# Access Compliance Report

## Public Rights-of-Way

### (Curb Ramps)

Intersection ID: 10031811	Main Street: MILLENNIUM_AV	Cross Street: POTOMAC_RIVER_PY	Location: E
ADA ID: 4859633A6B60	Ramp Type: Directional1	Initial Pass/Fail: Fail	Overall Compliance: No
Codes/Mitigation Info/Possible Solution		Field Measurements/Component Compliance	
Severity Score: 13.75

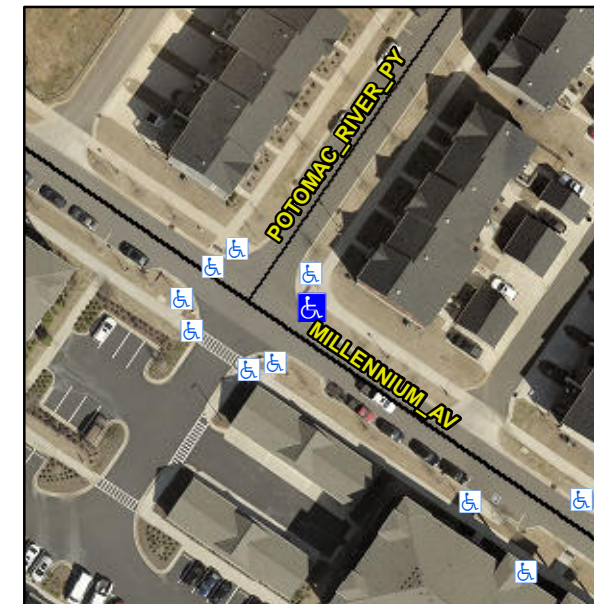
**R304.2.2, R304.5.3**

**Remove & Replace Entire Ramp.**
